Additions and Corrections

This report includes additional information and technical errors found between June 15, 2000, and April 1, 2003, in the inch-pound (I-P) edition of the 2000, 2001, and 2002 *ASHRAE Handbooks*. Occasional typographical errors and nonstandard symbol labels will be corrected in future volumes. The most current list of Handbook additions and corrections is on the ASHRAE web site (www.ashrae.org).

Fig. 22 Basic Heating System Schematic
(2000 HVAC Systems and Equipment, Chapter 11, p. 27)

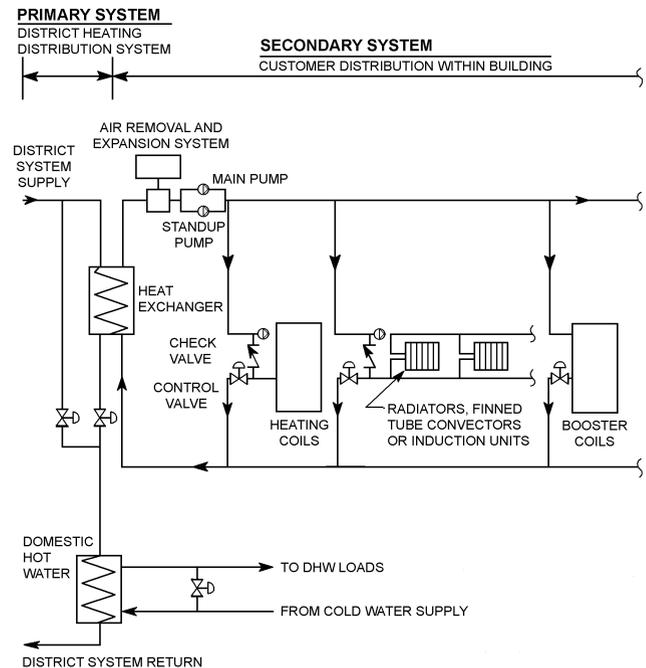
p. 11.27, Fig. 22. Replace Fig. 22 with the figure at top right, in which the primary and secondary systems are not shown to be connected.

Fig. 2 Stack Designs Providing Vertical Discharge and Rain Protection

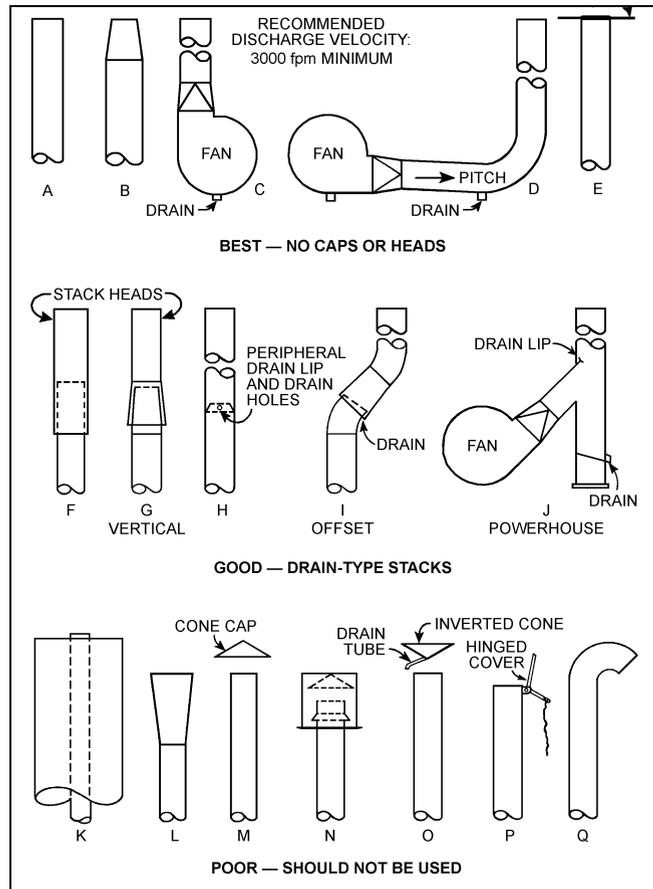
p. 34.23, Example 9, 2nd paragraph, 2nd line. Change “Figure 13 in Chapter 16” to read “Figure 2 in Chapter 43 of the 1999 ASHRAE Handbook—HVAC Applications.” Figure 2 is presented at right for convenience.

Fig. 1 Friction Loss for Water in Commercial Steel Pipe (Schedule 40)
(2001 Fundamentals, Chapter 35, p. 6)

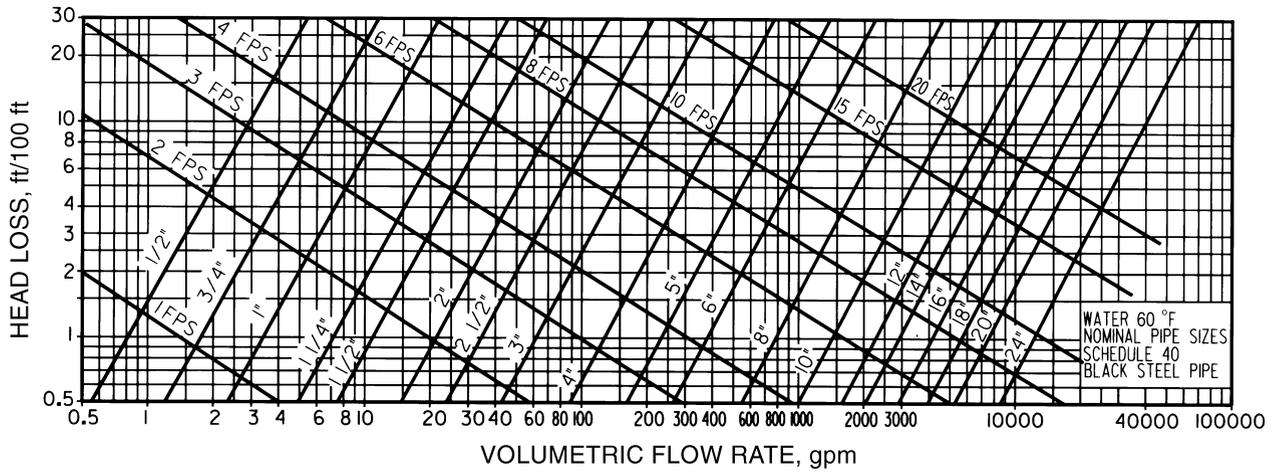
p. 35.6, Fig. 1. Replace Figure 1 with the corrected figure shown at the top of page 3.

Fig. 9 Friction Chart for Round Duct ($\rho = 0.075 \text{ lb}_m/\text{ft}^3$ and $\epsilon = 0.0003 \text{ ft}$)

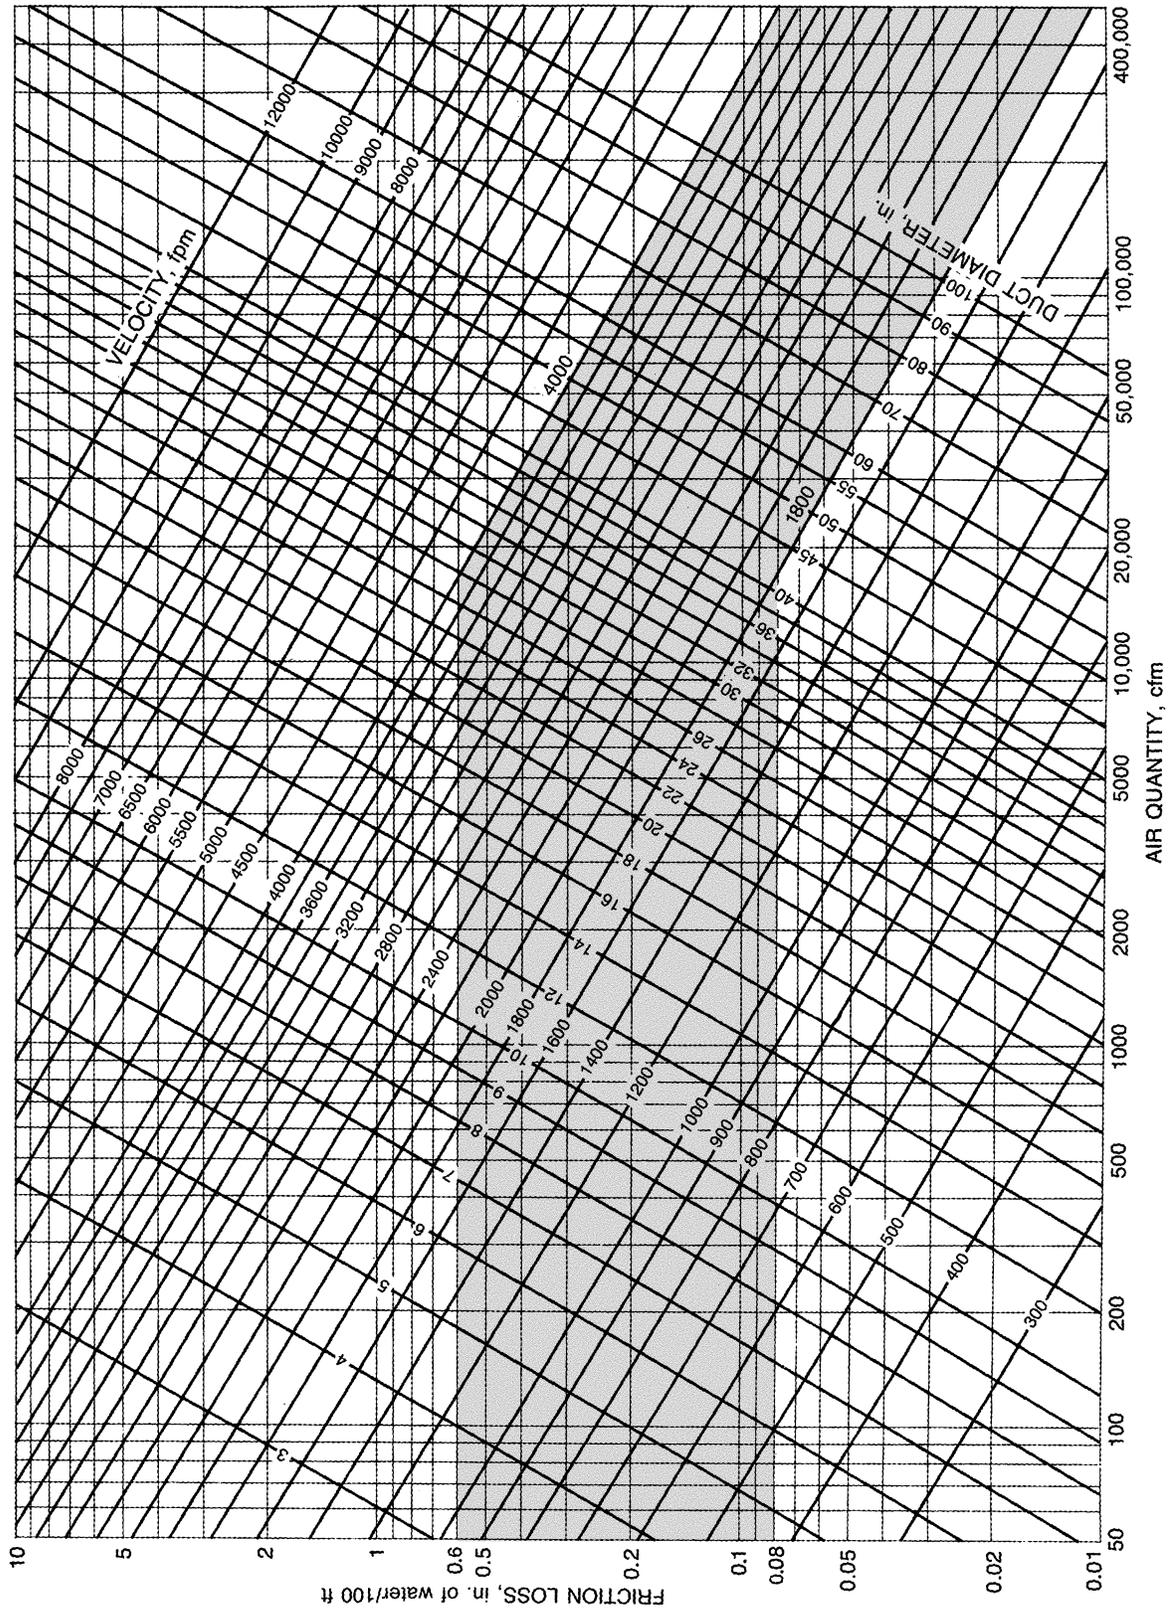
p. 34.9, Fig. 9. Replace SI value chart with I-P value chart (p. A.5)
